*City of El Paso – City Plan Commission Staff Report*

**REVISED**

**Case No:** SUSU13-00109 Stevens Addition Replat “B”  
**Application Type:** Resubdivision Combination  
**CPC Hearing Date:** December 19, 2013

# ATTACHMENT 3

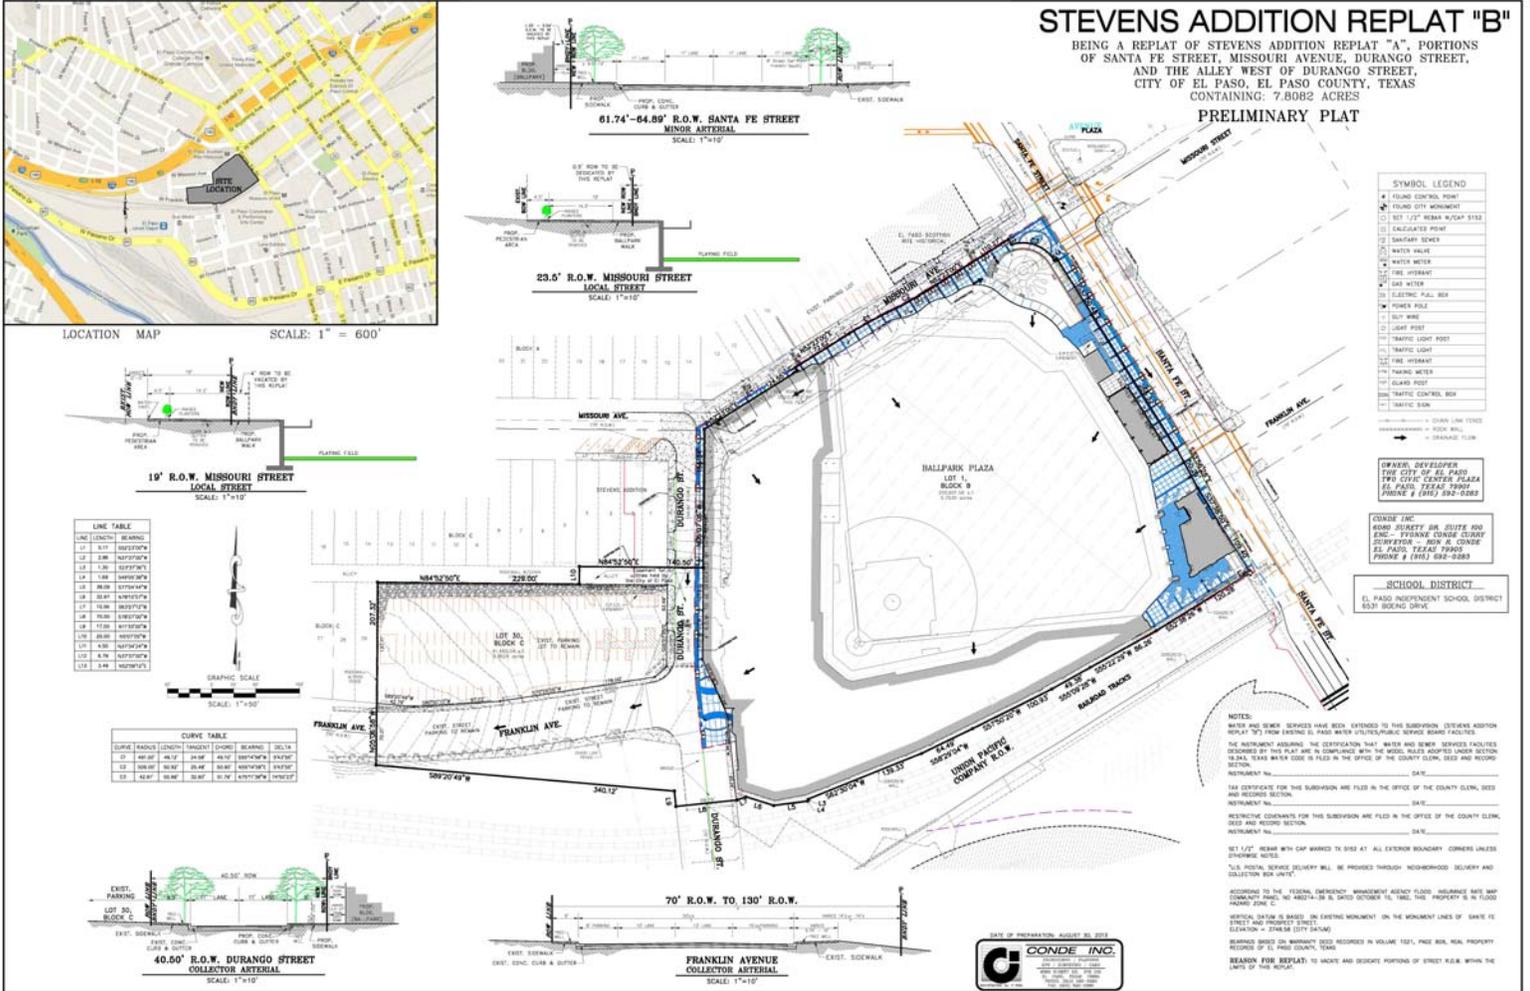
1. Label all topographic contours and elevations on preliminary plat.
2. Show and label all existing and proposed drainage structures.
3. Verify and dimension the minimum and maximum sidewalk widths are being provided along both sides of Franklin Street, Santa Fe. Street, and particularly along Missouri Street.
4. Show proposed runoff direction on typical street cross sections.

**23.5' R.O.W. MISSOURI STREET**  
**LOCAL STREET**  
 SCALE: 1"=10'

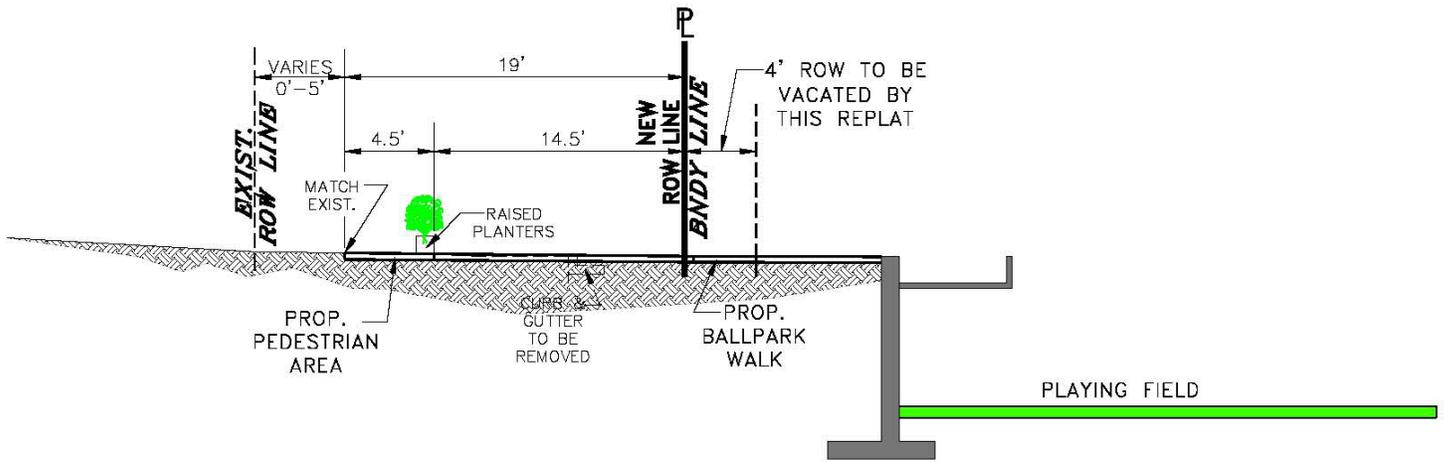
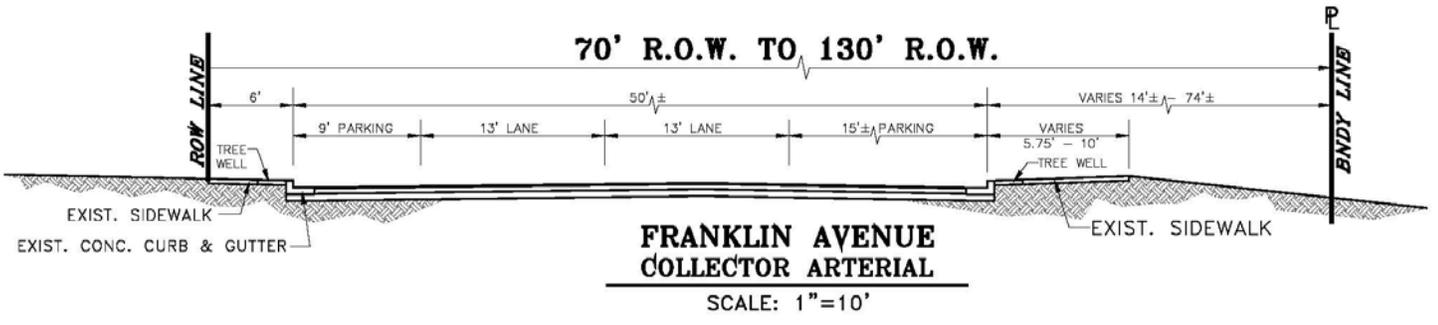
El Paso Fire Dept. has no objections, but the minimum 14 ft. paved roadway shall be maintained at all times. Whereas the ability to maintain an unobstructed width 20 ft. cannot be done, then the minimum of 19 ft. access R.O.W. that is capable of sustaining the 75,000 pound capacity shall be throughout the entire Missouri Ave.
